Memorandum

To: Bassett Creek Watershed Management Commission (BCWMC)
From: Barr Engineering Co. (Barr)
Subject: Item 4E: Brookview Golf Course Streambank Stabilization – Golden Valley, MN
BCWMC October 20, 2022 Meeting Agenda
Date: October 13, 2022
Project: 23270051.53 2022 2292

4E Brookview Golf Course Streambank Stabilization – Golden Valley, MN BCWMC 2022-13

Figure 2: Graphic to demonstrate proposed hybrid armoring technique

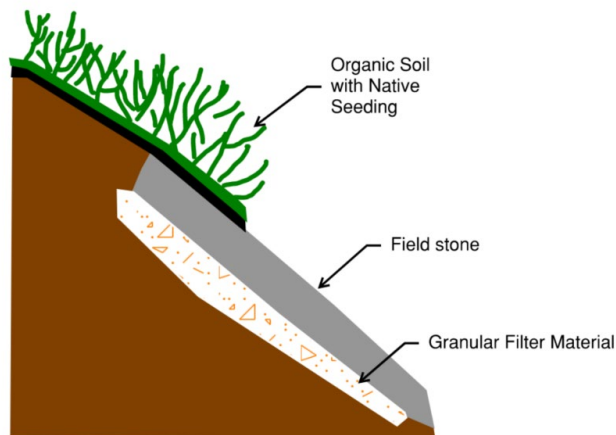
The BCWMC Stream Restoration and Protection Policies (policy 60) encourage the use of soft armoring techniques (rock vanes, geotextiles, plants, logs, etc.) as much as possible and wherever feasible as opposed to hard armoring techniques such as rock riprap. At a meeting with the city and its consultant, the hybrid stabilization approach and the Commission Engineers' recommendation to re-evaluate soft armoring solutions were discussed.

Given the shallow heights of the banks and site constraints, the applicant proposed a hybrid restoration technique that includes hard armoring practices (field stone) and soft armoring (partially buried field

stone with native seeding) as shown in Figure 2 and Figure 3. After the meeting, the city reviewed the plans along the outside bends and modified the design to remove over 100 cubic yards of rock by increasing soft armoring.
